STAFF RECOMMENDATION
2129 Belmont Boulevard
June 19, 2019

Application: New Construction- Addition
District: Belmont-Hillsboro Neighborhood Conservation Zoning Overlay
Council District: 18
Base Zoning: R8
Map and Parcel Number: 10416009600
Applicant: Matt McCrary, Allard-Ward Architects
Project Lead: Jenny Warren, jenny.warren@nashville.gov

<p>Description of Project: Application is a revision to a previously approved rear addition.</p>	<p>Attachments A: Site Plan B: Elevations</p>
<p>Recommendation Summary: Staff recommends approval of the proposed addition with the following conditions:</p>	
<ol style="list-style-type: none">1. Staff approve the final doors and windows prior to purchase and installation; and,2. The HVAC shall be located behind the house or on either side, beyond the mid-point of the house; and3. Staff approve the material of the back porch columns	
<p>Staff finds that the project meets Section II.B of the <i>Belmont-Hillsboro Neighborhood Conservation District: Handbook and Design Guidelines</i></p>

Figure 3: Ashwood Avenue elevation

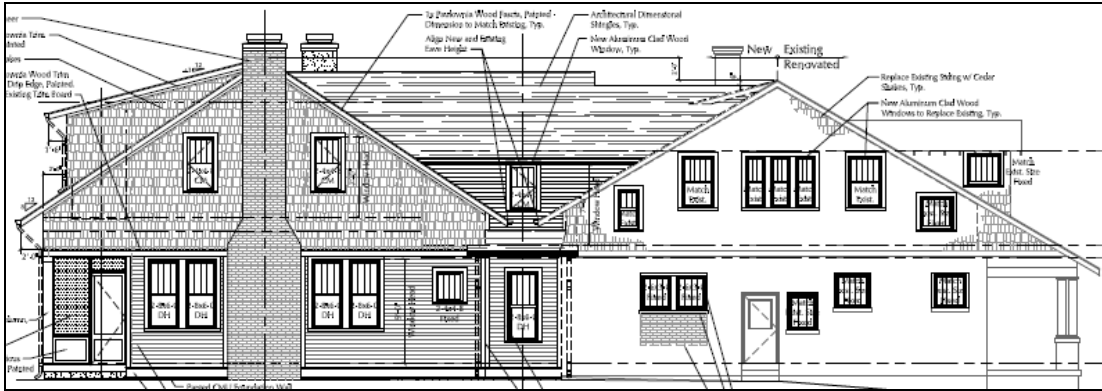
Height & Scale: The addition will use a side gabled roof form, like the historic house. The new ridge will sit about forty-four feet (44') beyond the historic ridge and the height of the new ridge line will be about two feet (2') taller than the historic ridge, at about twenty-six feet, six inches (26'6") tall. A section of rear gabled roof will connect the two ridges and will sit six inches (6") below the historic ridge line, as per the guidelines. This section will step up one foot (1') approximately forty-feet (40') back from the front of the house, as is allowed by the guidelines. Then the new side gable will be an additional one foot (1') taller (Figures 3 & 4).
